SERVICE BULLETIN

SB-090817 REV F

DATE ISSUED: 8/26/2024
DATE EFFECTIVE: 4/11/2018
SUPERSEDES NOTICE: SB-090817 Rev E
SUBJECT: Lower Roll Control cable wear at wing fold socket
AIRCRAFT AFFECTED: **MODEL:** ICON A5
S/N: 00001-00027

Figure 2: Indication of wear between the control cable and the inboard rod end of the inboard pushrod (wing side).

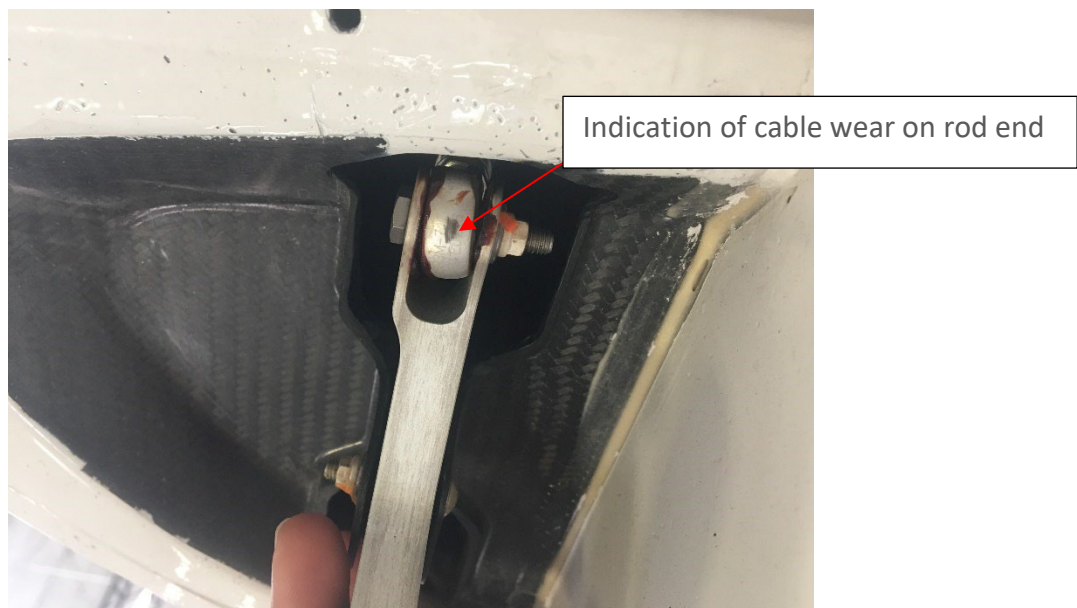
- 1) Inspect lower roll control cable at the socket and the inboard rod end of the inboard aileron pushrod for indications of wear.
 - a. If there is evidence of wear continue inspecting every 10 hours of flight time to the limits described and replace if necessary. See attached Log Entry table.
 - b. If there is no evidence of wear, there is no further action required with reference to this notice.

1. Fold each wing and visually inspect both the inboard rod end of the inboard pushrod on the wing and the lower roll control cable terminal at the bottom of the roll socket at the wing fold joint.
 - a. If there **is** evidence of wear on the rod end as shown in figure 3 or the roll control cable as shown in figure 4 carefully inspect the end of the roll control cable for any broken strands as shown in figure 3.
 - i. If there are any broken strands – Replace the cable following the instructions below.
 - ii. If there is wear but no broken strands – Continue to inspect the roll control cable for broken strands every 10 hours.
 - b. If there is **no** evidence of wear on the rod end or roll control cable – no further action with respect to this bulletin is required.

Figure 5: Roll control system overview

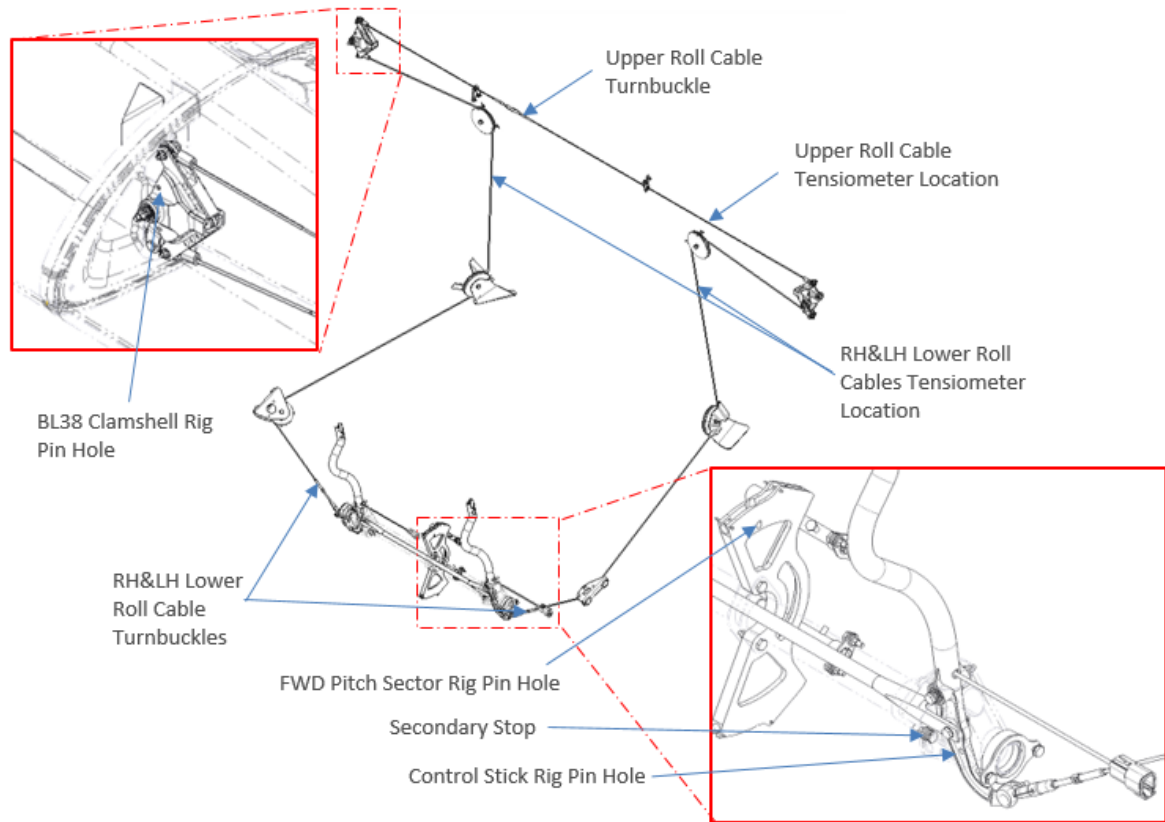
1. Disassemble the aircraft as required to permit accessibility, inspection, adjustment, maintenance, and repair in accordance with the latest release of the Aircraft Maintenance Manual, ICA000833.
 - a. This will require removal of:
 - i. Baggage floors,
 - ii. Both seat backs and seat bases
 - iii. Cockpit interior side panels
 - iv. Baggage side panels, and headliner
2. De-tension the affected lower flight control cable by removing safety wire or turnbuckle clips and loosen the turnbuckle located at the torque tube entrance shown in figure 5 below.

1. Starting from the center wing loosely route new lower roll cable from the roll socket to the torque tube bearing. Use figure 5 for routing path.
2. If the roll pulleys were removed, reinstall the bolts as shown and torque to 48 in-lb., if the safety pins were removed re-install with a new MS25665-151 cotter pins.

5. Install .1875" rig pins at both roll sockets, left side control stick base, and .250" rig pin in the center section pitch sector as shown in figure 5 above.

6. Slowly rotate the lower roll control cable turnbuckle (ensuring that the cable not wound up during the tension process) on the replaced cable until the cable tension is set at 25-30 lb. as measured in the locations shown in figure 5. Measure all three locations and adjust the other cables if they are not 25-30 lb. tension.

Figure 6: Roll Socket and torque tube connection points.

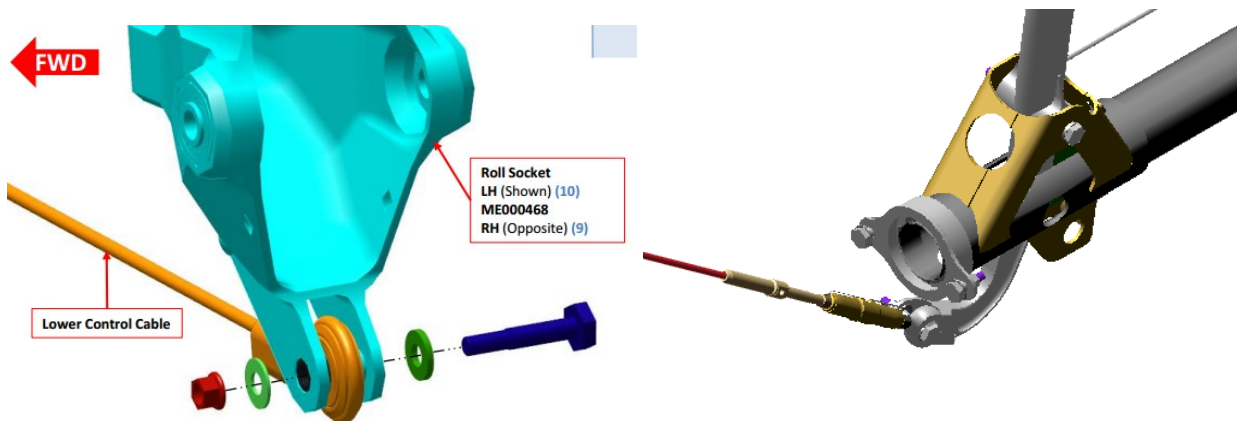
3. Disconnect the lower roll cable at the roll socket and at the turnbuckle at the stick. Ensure that cable is held while disconnecting the turnbuckle.

3. Connect the lower roll cable to the lower roll socket attachment point as shown in figure 6 above. Torque hardware to 20 in-lb.
4. Connect the roll cable to the rod end still attached to the cockpit control stick at the same time as connecting to the roll cable such that the threads are balanced. Ensure that when tightening the turnbuckle that the cable is held as to not wind the cable. Do not fully tension the cable system during this step.
